## ADDENDUM NO. 2

June 5, 2007

To Plans and Specifications for:  
Community Storm Shelters for the Bibb County Commission  
Architect's Project No. 0514  
BC #2006410

**SD-01**

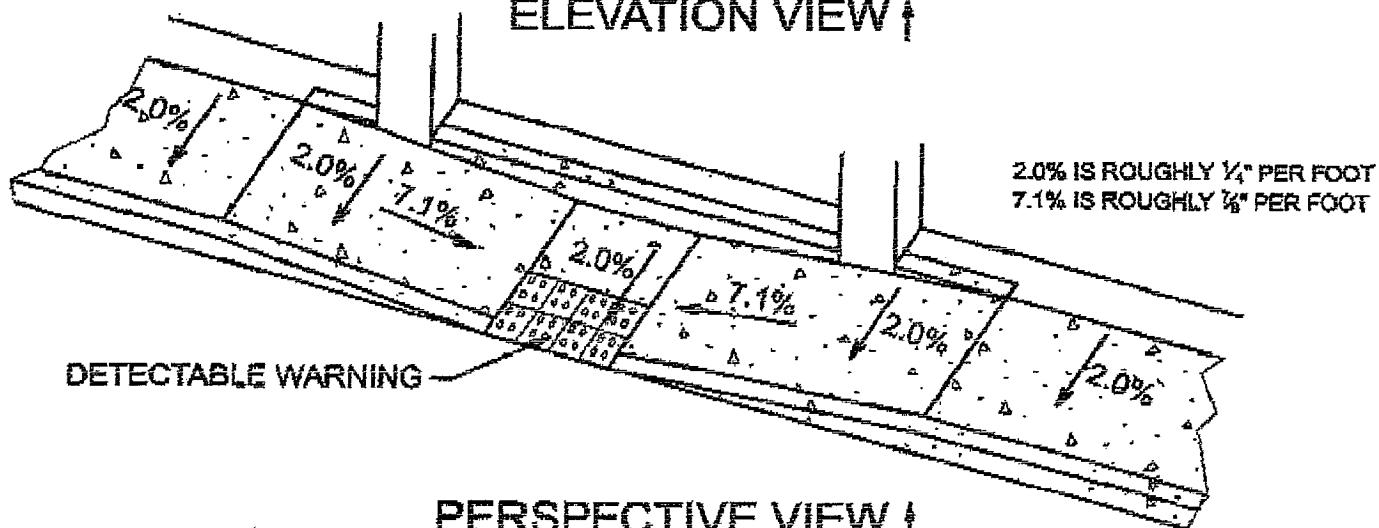
- A. Refer to the attached supplemental drawing SD-01 as provided by Brooks & Brooks dated 05/31/07: The ADA compliant curb ramp at Woodstock Elementary shall be constructed as detailed on this supplemental drawing.
- B. Refer to S0.0, details 2 and 3: Clarification: The CMU walls can be constructed before the concrete roof deck (and completely shored) and the bond beam can be poured integrally with the roof deck. The 6" by 6" angle clips will still be required.

THIS DRAWING PROVIDES GUIDELINES FOR THE CURB RAMP SHOWN ON THE PLANS. THE RAMP MUST BE ADA COMPLIANT, THEREFORE IT MUST BE CONSTRUCTED AT GRADES SHOWN (INDICATED BY PERCENTAGES) AND HAVE THE DETECTABLE WARNING STRIP. THE DETECTABLE WARNING STRIP MUST INCLUDE TRUNCATED DOMES IN ACCORDANCE WITH THE ADAAG. FOR MORE INFORMATION REFER TO CHAPTER 6.3 (DETECTABLE WARNINGS) AND CHAPTER 7 (RAMPS), FHWA BEST PRACTICES DESIGN GUIDE, WHICH CAN BE FOUND AT [www.fhwa.dot.gov/environment/sidewalk2](http://www.fhwa.dot.gov/environment/sidewalk2)
